737-9/-900ER MED Plug Enhancements
Subject to final certification

Six Additional Safety Features Added

New Retention Arm Assemblies

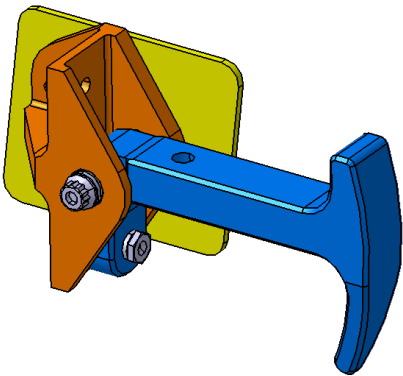
- Two assemblies prevent the plug from translating upward and becoming misaligned from fuselage stop fittings.
- If Retention Arm is not in the properly stowed position, it interferes with the installation of the interior sidewall panel

Enhanced Primary Retention Features

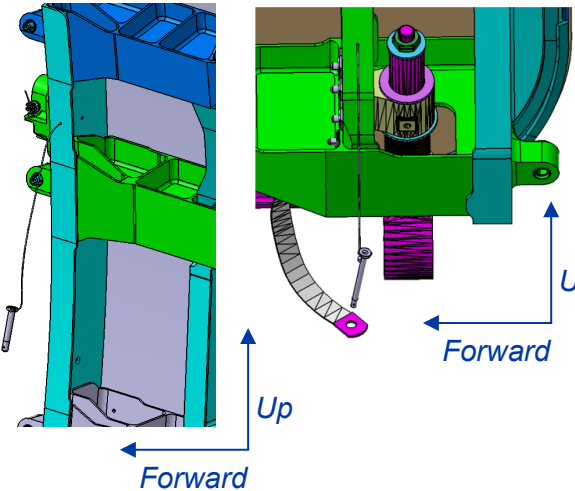
- Four existing bolts securing plug to fuselage now permanently attached to plug via safety wire 'lanyard'
- Lanyards allow for plug installation and removal, but provide visual indications if bolts are not re-installed.
